ORDINANCE NO. 3373-14

**An Ordinance Amending the Development Agreement
for the Everett Riverfront District Properties
Related to the Simpson Site and Eclipse Mill Site, Amending Ordinance No. 3121-09**

**EXHIBIT 1
FIRST AMENDMENT
TO
DEVELOPMENT AGREEMENT**

Preliminary Development Plan – Revised Simpson and Eclipse Neighborhood Plans (Replaces pg. 1 of Attachment E to Dev. Agreement)

Preliminary Development Plan PDO Site Plan— Revised Basic Height Limits

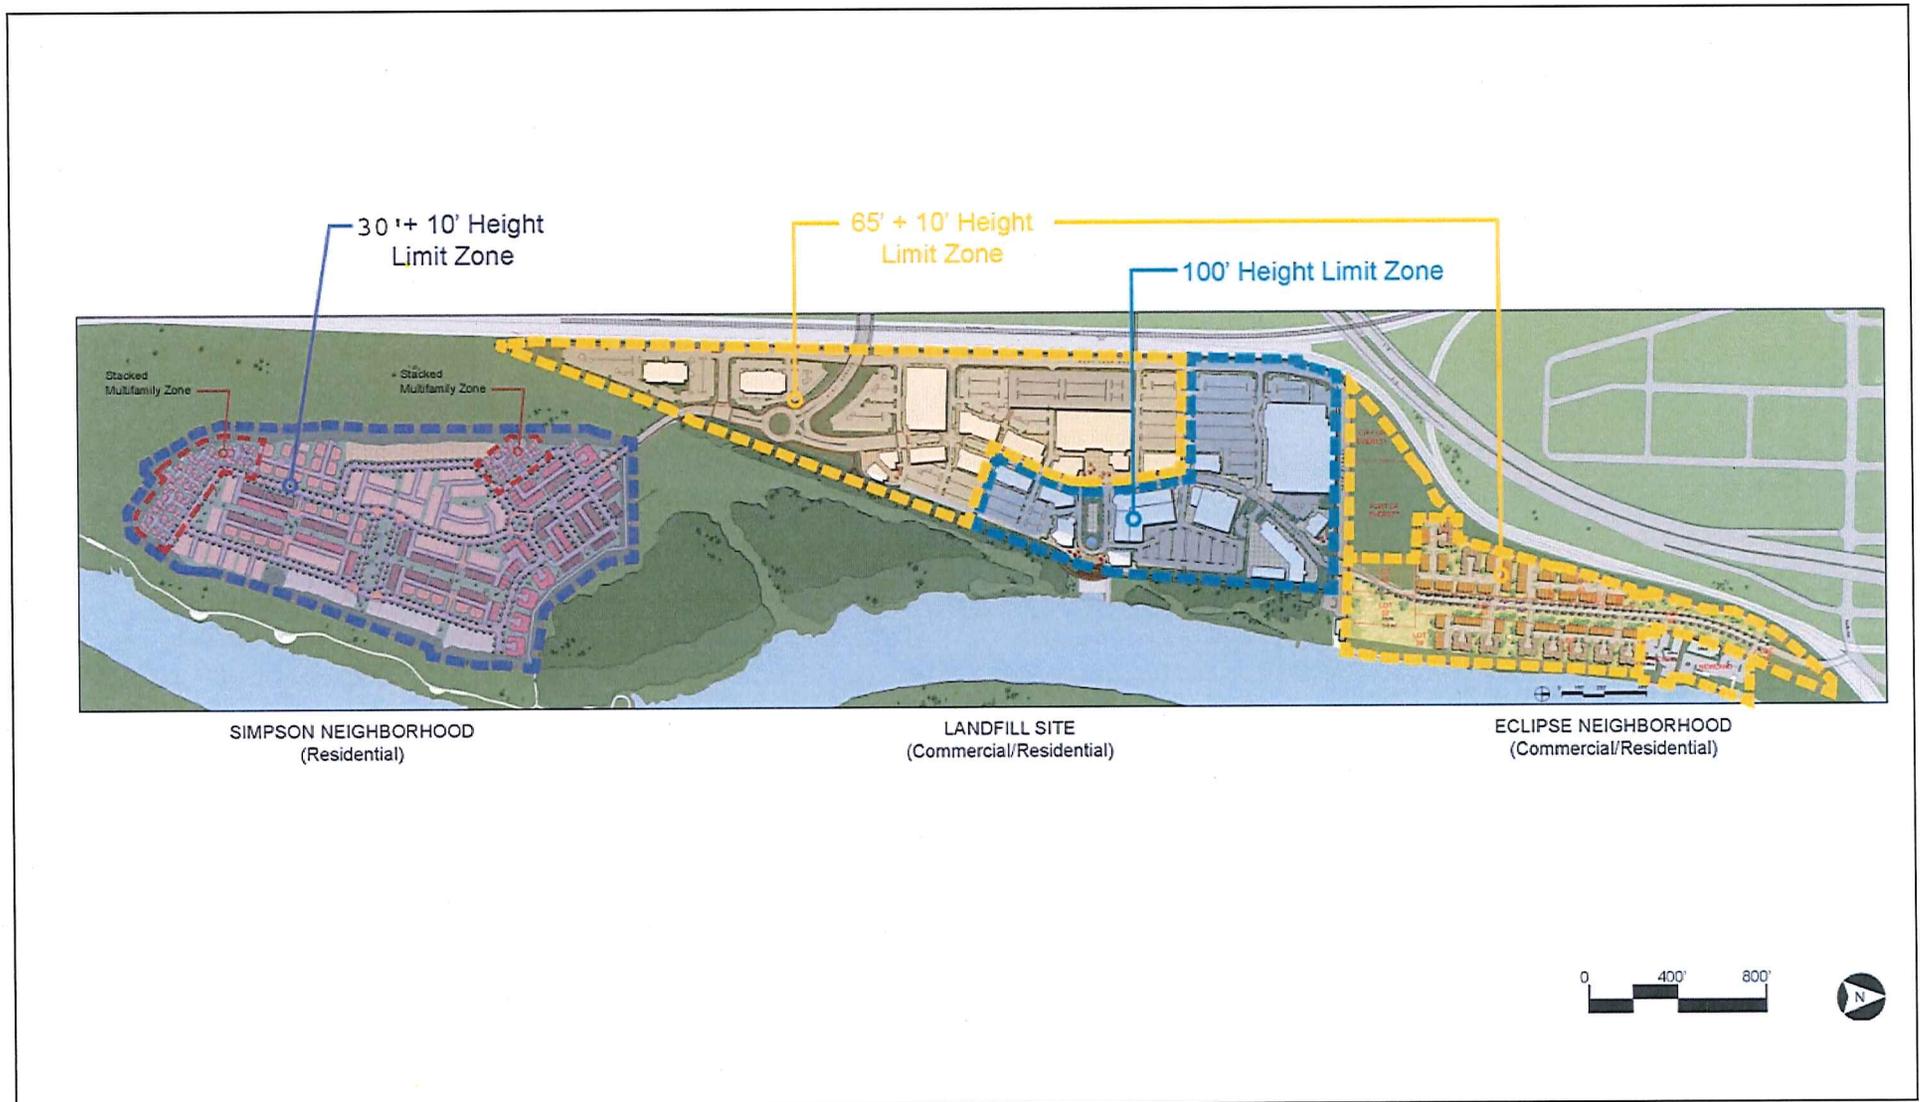
(Simpson Neighborhood Height Limit changed from 35' + 10' to 30' + 10' due to additional fill on site)

<p>Pg. 10 Maximum Building Height</p>	<p>4. <u>Maximum Building Height.</u> Maximum height limits shall be per the PDO site plan as follows:</p> <ul style="list-style-type: none"> • Simpson: 35'<u>30'</u> • Eclipse: 65'

**Pg 5 (Concept
Plan for
Overall Site)**

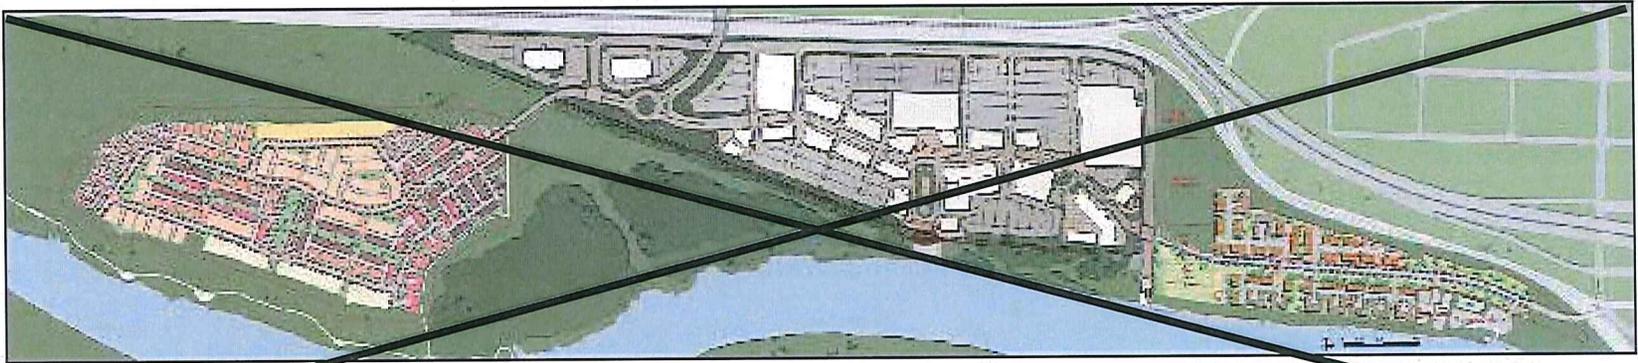
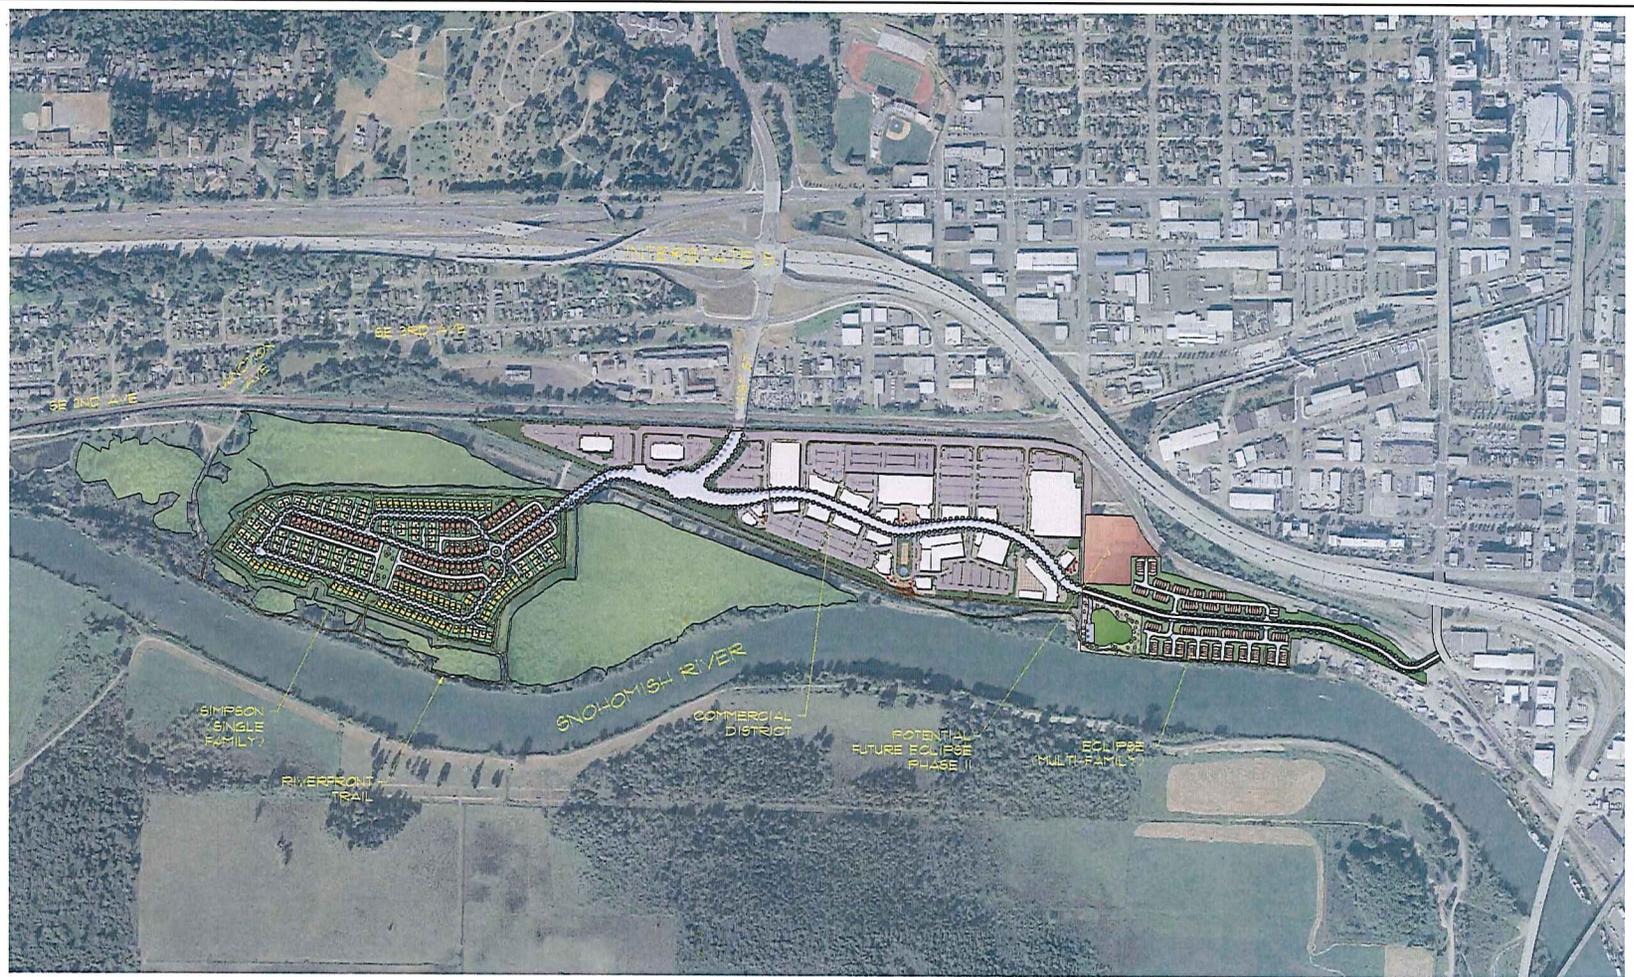
Delete existing plan for Simpson Neighborhood and Eclipse Neighborhood

Revised concept plans for Simpson Pad and Eclipse Mill Site (no changes to Landfill Site)

Pg. 6
(Concept Plans
Simpson
Neighborhood)

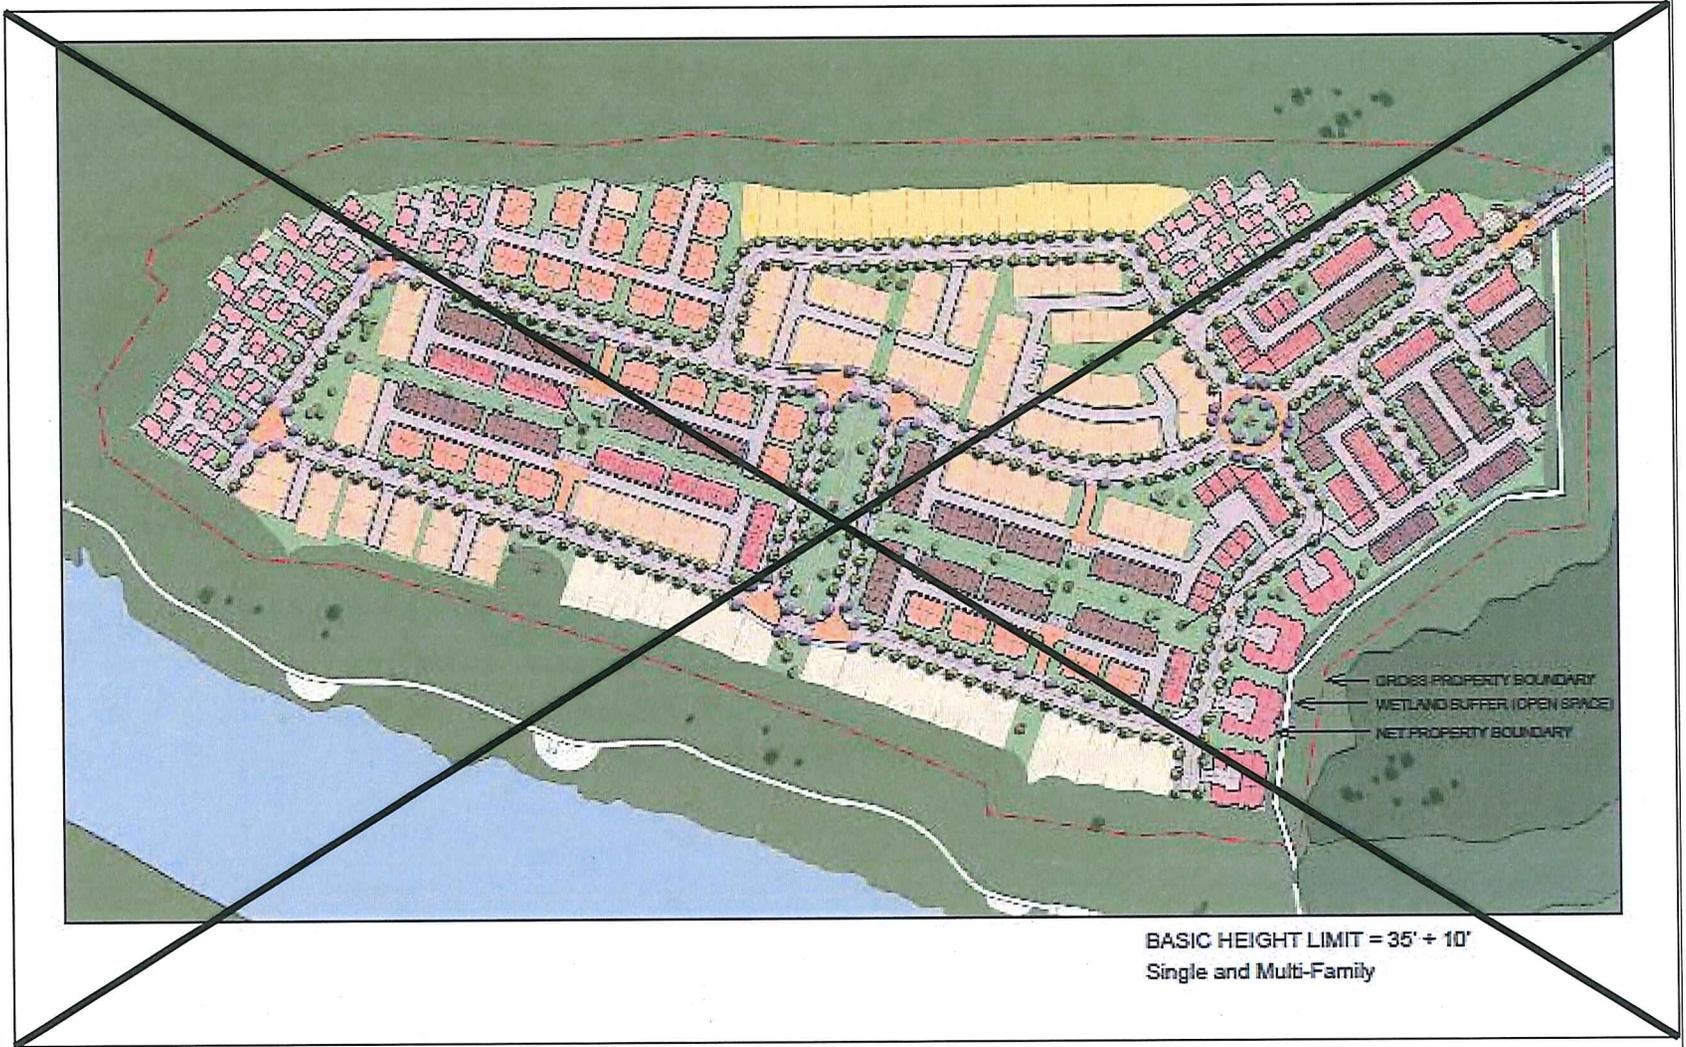
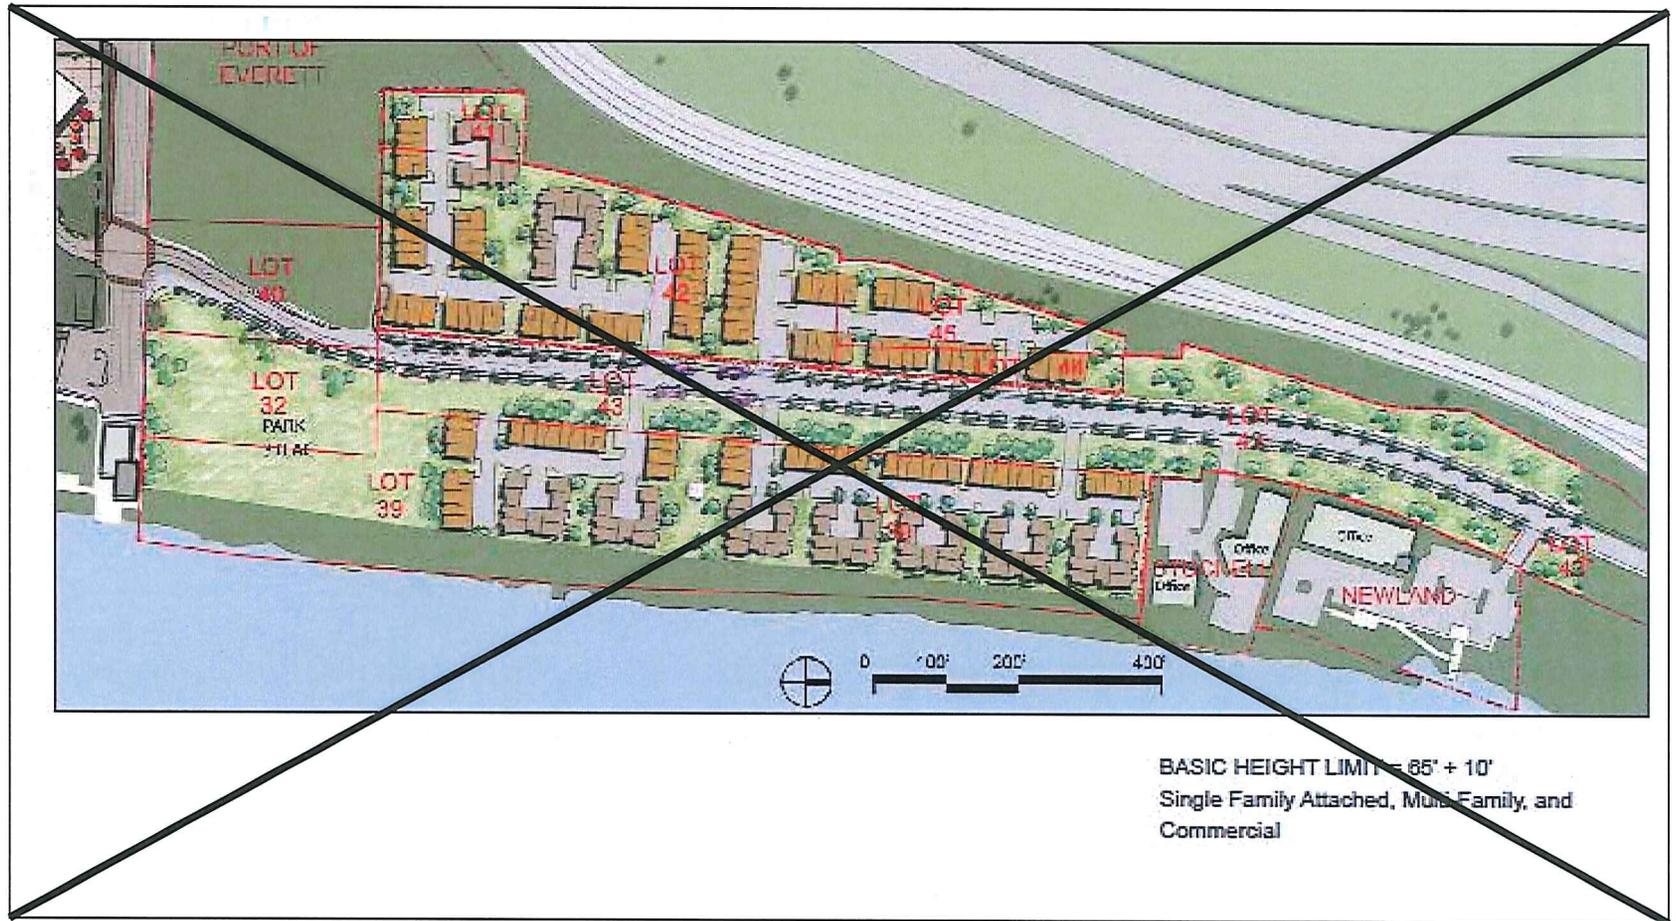
Delete existing plan

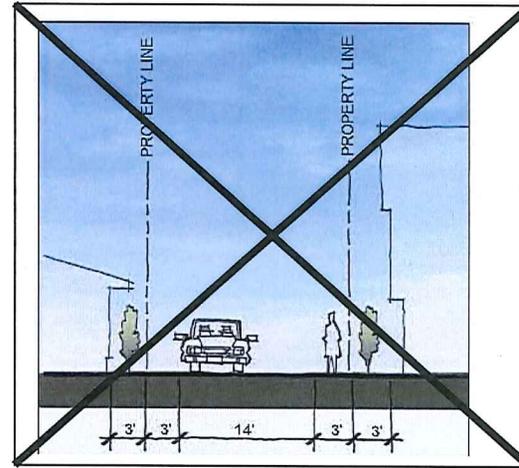
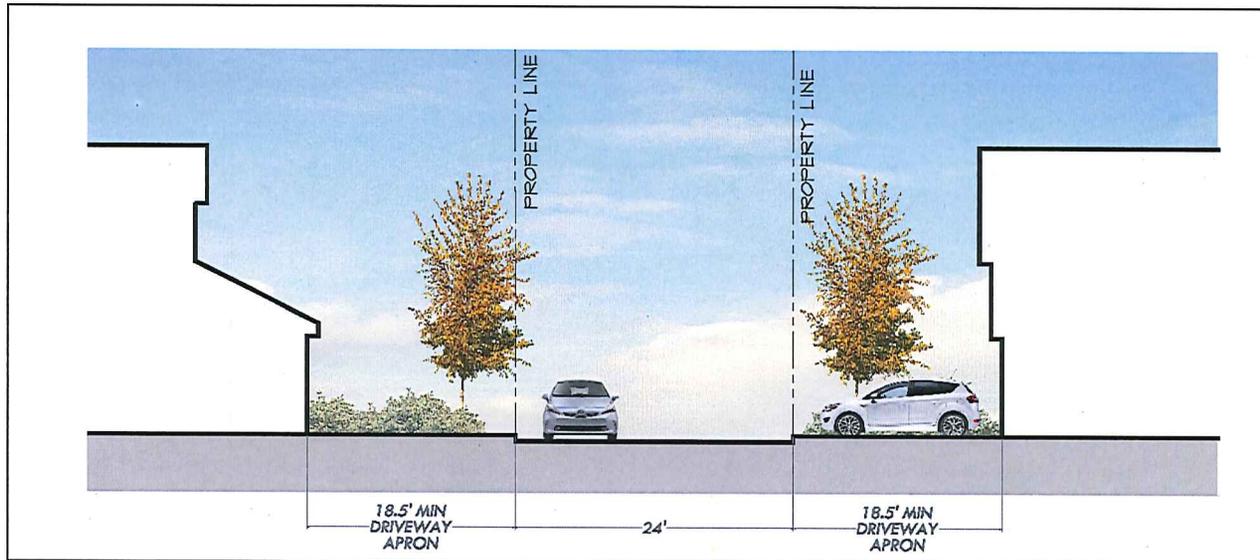
Delete Existing Graphics for Alley / Lane

Add Proposed Graphics for Private Access Lanes

Private access lanes are required to be constructed of concrete pavers, stamped asphalt, or other decorative and distinctive paving features as approved by the City Engineer.

Private alleys are also 24 feet wide. However, an 18.5 foot driveway apron is not required. Distance from the garage to the opposite side of the alley must be a minimum of 26 feet.

Pg. 12 (open space)

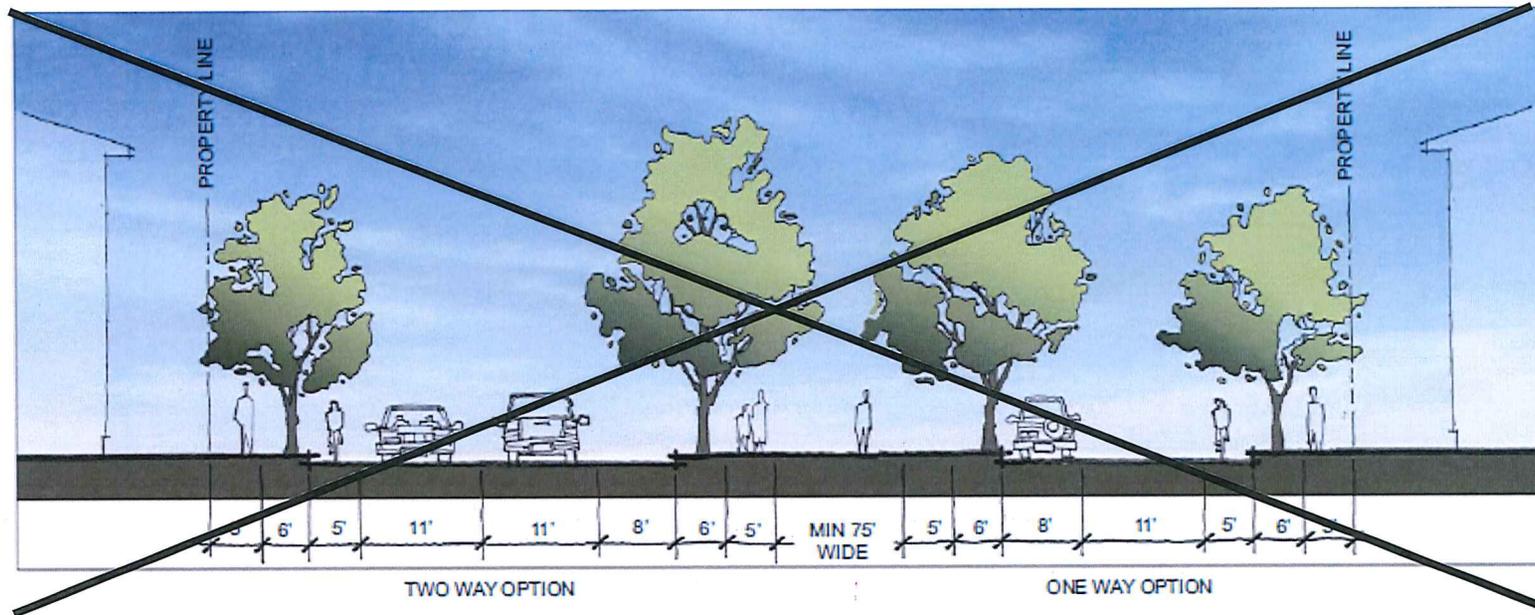
The existing graphic for the neighborhood green is deleted:

Pg. 13 (front loaded garage)

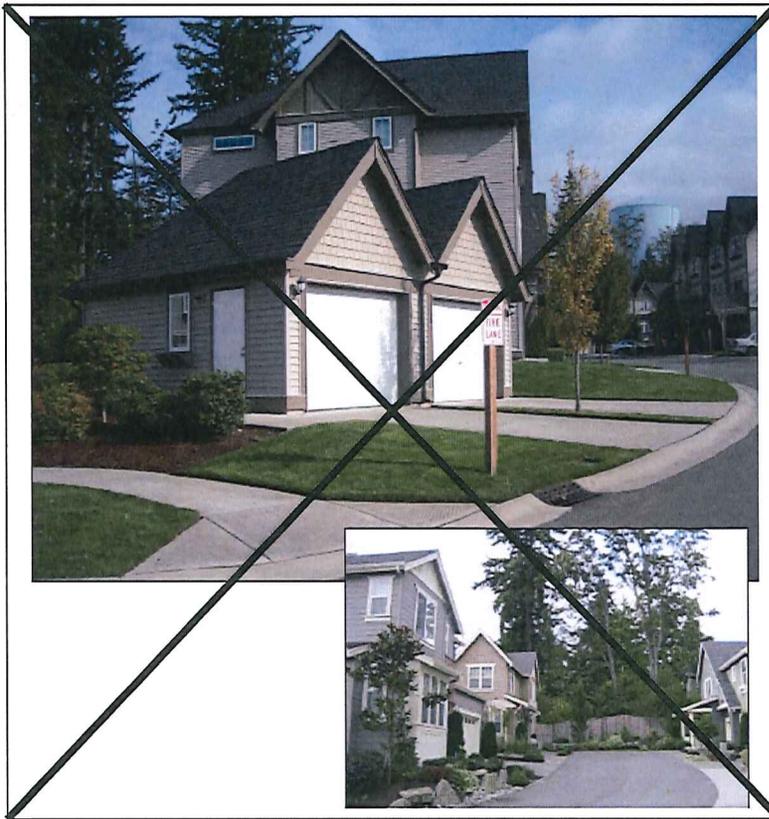
emphasized or hidden, helping to create a neighborhood that feels more like a place for people than a place for cars. Last version had deleted the highlighted text.

However, ~~w~~Where front loaded garages are used, parking aprons shall be provided in length that prevents vehicles from overhanging the adjacent sidewalk, walkways, alleys or lanes.
